**SECTION 75W MODIFICATION APPLICATION – ENVIRONMENTAL ASSESSMENT REPORT
BARANGAROO CONCEPT PLAN MP06_0162 (MOD 11)**

This Environmental Assessment Report (**EAR**) is submitted to the Department of Planning, Industry and Environment (**DPIE**) in support of a Section 75W modification to Concept Plan Approval MP06_0162 pursuant to clause 3C, Schedule 2 of *Environmental Planning and Assessment (Savings, Transitional and Other Provisions) Regulation 2017* (**Savings and Transitional Regulation**).

Figure 1: Barangaroo Concept Plan (MOD 8) – Appendix 1

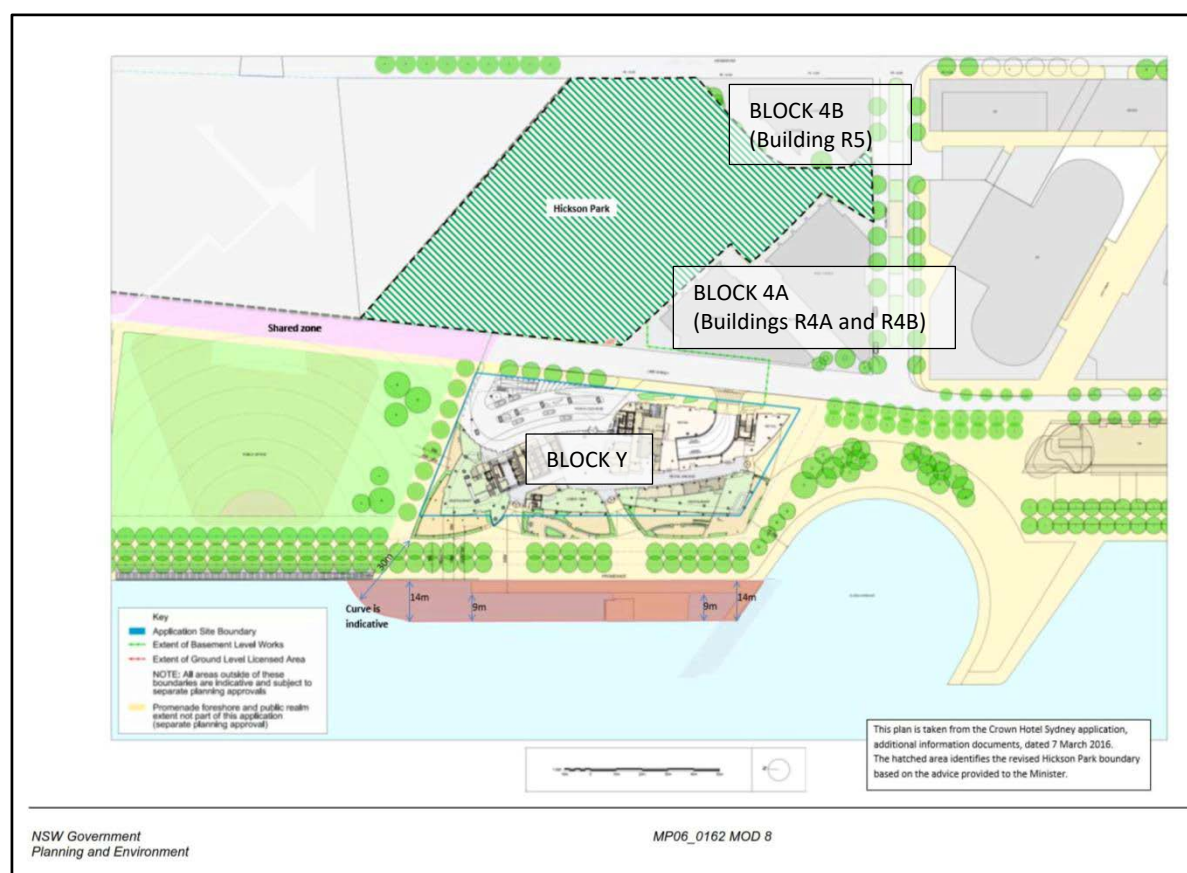
Hickson Park is defined in Condition B3(1)a) by reference to the map at Appendix 1 of MOD 8 outlined in Figure 1 of this EAR. For context, this map was prepared several years before the Development Application for the Public Domain (comprising the detailed design of Hickson Park and the surrounding public domain areas) was prepared and consent was granted (SSD 7944).

In relation to the area of Hickson Park located on Block 4, it is noted that if the full extent of Hickson Park as reflected in the map at Appendix 1 of MOD 8 is required to be completed and publicly accessible before the Amenities Building and each of the R4A, R4B and R5 Buildings have been completed, it will result in one or more of the following unsatisfactory outcomes:

Insert New Appendix 1 – Hickson Park

Reason for Modification: For consistency with SSD 7944.

Figure 3: Road network in Barangaroo South including Barton Street

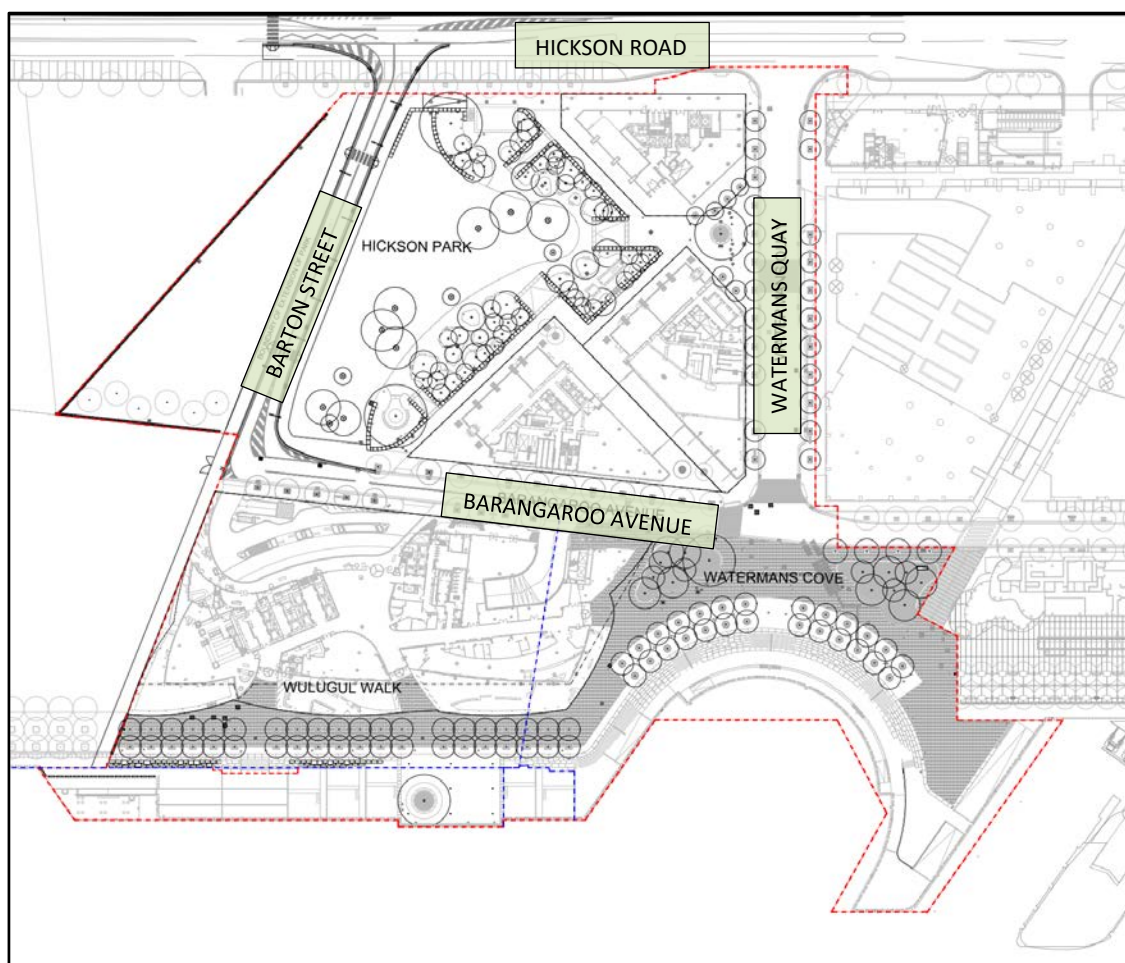
Condition C8 provides that the intersection of Barton Street with Hickson Road shall be for temporary construction purposes only, and Infrastructure NSW is seeking to modify the Concept Plan to allow Barton Street to operate as a temporary public road (i.e. for all vehicles) to ease pressure on the road network while development in Barangaroo South and Central Barangaroo is occurring. No changes are proposed to the road design.

*(5) Barton Street is approved as a temporary road ~~only~~ ***for construction vehicles and non-construction vehicles*** and is subject to the future environmental assessment requirements in C8.*

The provision of any future intersection with Hickson Road in the vicinity of the boundary between Block 4 and 5 shall be for the temporary road (Barton Street) ~~temporary construction purposes only~~ and is to ensure that pedestrian access between Hickson Park and the waterfront in the vicinity of Block Y is prioritised. In this regard, any relevant future public domain application shall be designed to minimise the potential for vehicular and pedestrian conflict and shall be designed and appropriately treated to improve road and pedestrian safety. Any future application shall also be accompanied by a Road Safety Audit.

Figure 4: Hickson Park area completed prior to the issue of an Occupation Certificate for the Crown Sydney Hotel Resort on Block Y

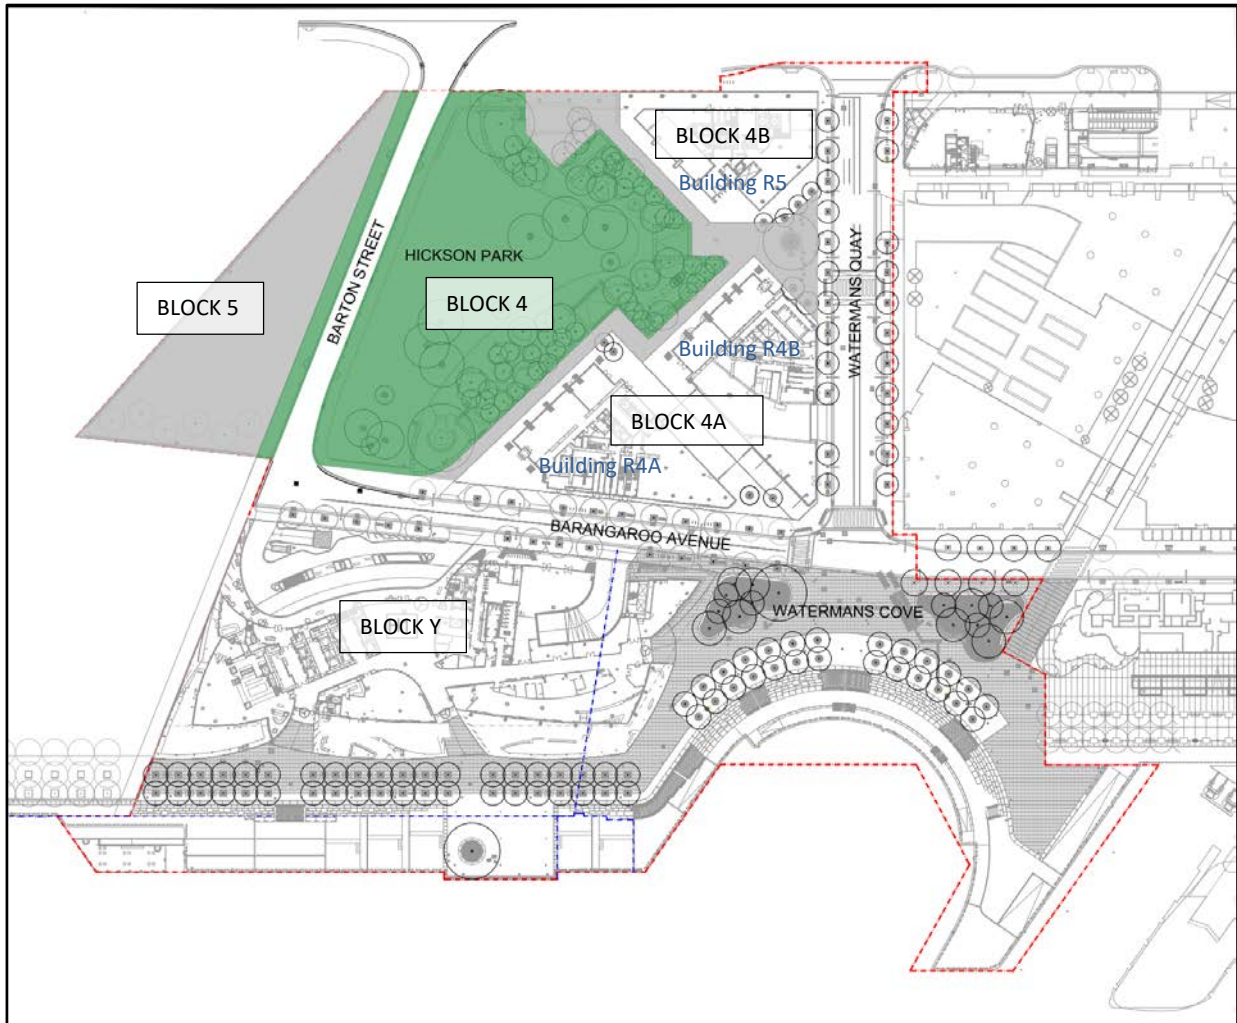
For completeness, prior to the issue of an Occupation Certificate for the Crown Sydney Hotel Resort (SSD 6957) (As Modified), all other areas of the public domain required to be constructed, landscaped and publicly accessible in accordance with Condition B12, including the foreshore promenade known as Wulugul Walk, Waterman's Cove, the Pier, Barangaroo Avenue, Barton Street will be completed, together with the extent of Hickson Park illustrated in the **Figure 4** below.

The proposed staging of the exclusion zones reflects the program for the delivery of Buildings R4A, R4B, and R5 and will allow the extent of Hickson Park as defined by the large grassed area, extensive planting beds, ramped entrances and the sandstone retaining walls at the southern end to be completed (as illustrated in Figure 4 above) prior to the opening of the Crown Sydney Hotel Resort in late 2020.

Hickson Park (other than the road corridor for Barton Street) shall be completed in accordance with the Staging Plan Nos 1-7 (BAR418-SIN-SK-063) prepared by Grant Associates and dated 04.06.2020.
